# RENESAS TECHNICAL UPDATE

Product Category	MPU&MCU	Document No.	TN-SH7-A600A/E	Rev.	1.00
Title	Error corrections and addition of usage notes to the SH7261 Group and SH7201 Group Hardware Manuals		Information Category	Technical Notification	
Applicable Product	SH7261 Group SH7201 Group	Lot No.	Reference Document	SH7261 Group Hardware Manual Rev.1.00 REJ09B0320-0100 SH7201 Group Hardware Manual Rev.1.00 REJ09B0321-0100	
		All lots

We would like to inform you of error corrections and addition of usage note to the SH7261 Group and SH7201 Group Hardware Manuals (Rev.1.00). Please take this information into consideration when using these products.

**Figure 9.21 Byte Write Timing to SDRAM with 16-Bit Bus Width (Example)**

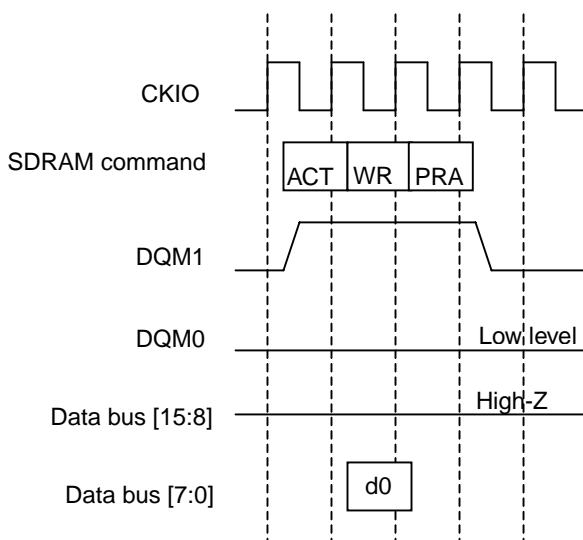
The description on (c), [Byte Access Control by DQM](#), and two figures (figures 9.21 and 9.22) are newly added. The number of following figures will be modified accordingly.

Figure 9.21 shows a timing example for byte writing to the SDRAM with a 16-bit bus width, and figure 19.22 for byte reading from the SDRAM with a 16-bit bus width. In the SDRAM access, the DQM signal is asserted when data is masked.

**Figure 20.18 Operation Timing when Transmission has not been Completed within Maximum Number of Transmit Bytes**

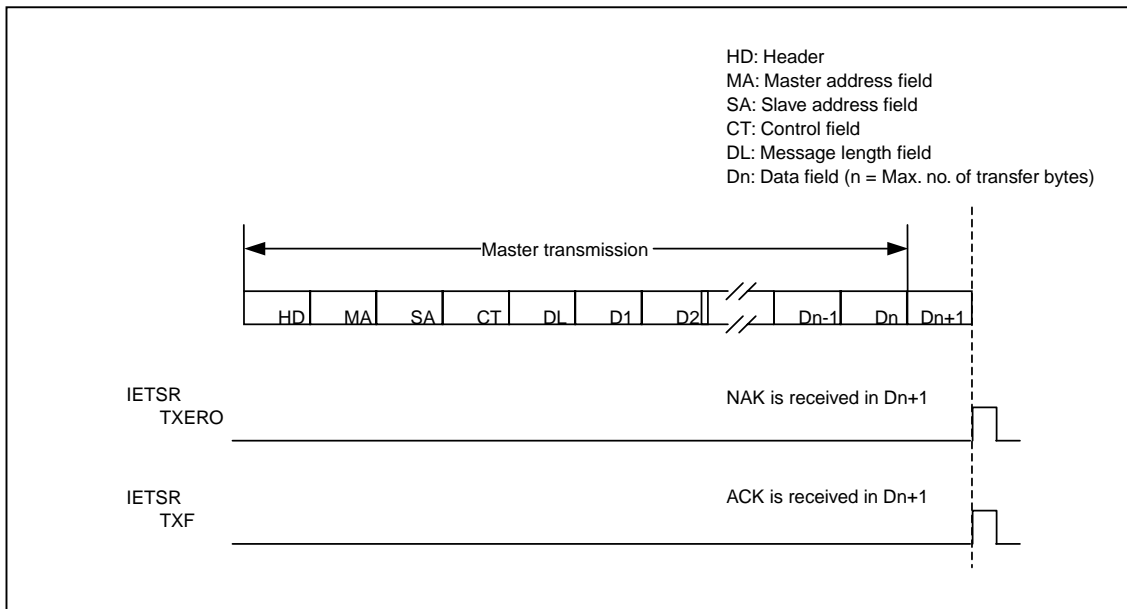
The description on section 20.8, [Usage Notes](#), is added.

During the data transmission, when the maximum number of bytes defined by the communications mode have been transmitted because a NAK has been received from the receive unit, or when transmission has not been completed within the maximum number of transmit bytes because the message length value exceeds it, the IEB sets the error flag of IETSR and enters the wait state. In this case, the IEB transmits data for the maximum number of transmit bytes + one byte. Then, if a NAK has been received in an acknowledge bit of data for the maximum number of transmit bytes + one byte, the TXERO flag is set. If an ACK is received, the TXF flag is set.

Figure 20.18 shows the operation timing when the transmission has not been completed within the maximum number of transmit bytes.

Figure 20.19 Operation Timing when Reception has not been Completed within Maximum Number of Receive Bytes

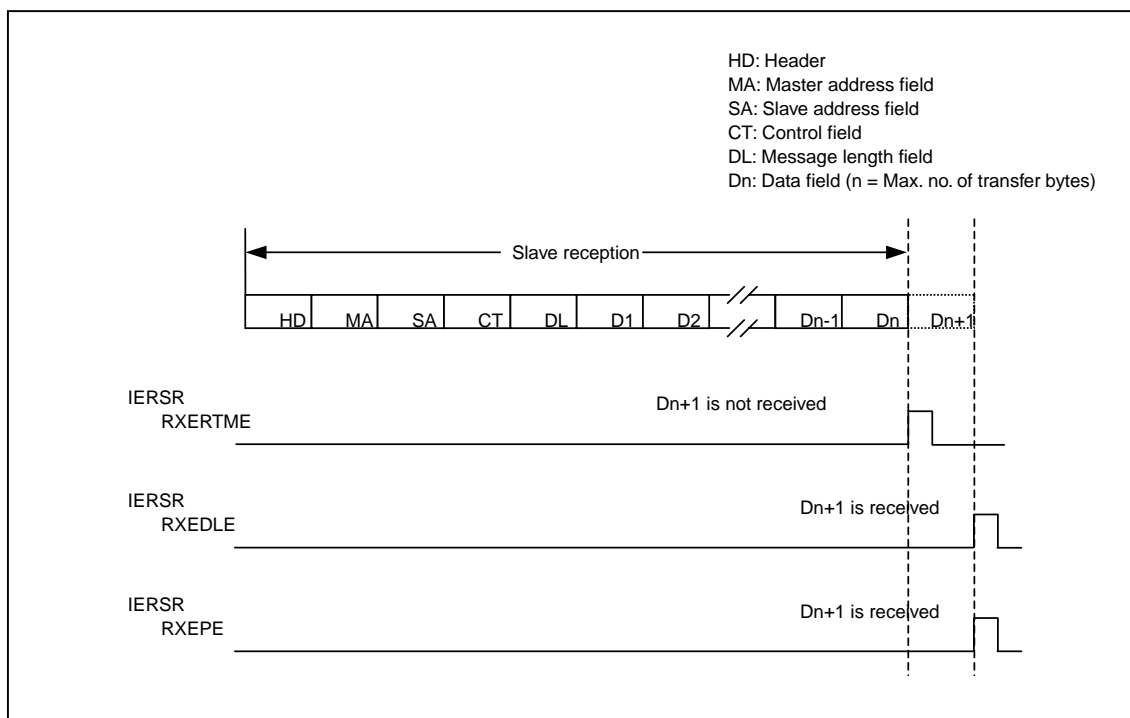
During the data reception, when reception has not been completed within the maximum number of bytes defined by the communications mode because of a parity error or overrun error causing the retransfer of data, or when reception has not been completed because the message length value exceeds the maximum number of receive bytes, the IEB sets the error flag of IERSR and enters the wait state. In this case, the IEB waits for data for the maximum number of receive bytes + one byte. Then, if data for the maximum number of receive bytes + one byte is not received, a receive timing error is detected and the RXERTME flag is set. In this case, the RXEDLE flag is not set. The RXEDLE flag is set when data for the maximum number of receive bytes + one byte is received.

The IEB also waits for data for the maximum number of receive bytes + one byte, when the maximum number of receive bytes have been received but the parity error is not cleared. If data for the maximum number of receive bytes + one byte is not received, the RXERTME flag is set. In this case, the RXEPE flag is not set. The RXEPE flag is set when data for the maximum number of receive bytes + one byte is received.

Figure 20.19 shows the operation timing when the reception has not been completed within the maximum number of receive bytes.
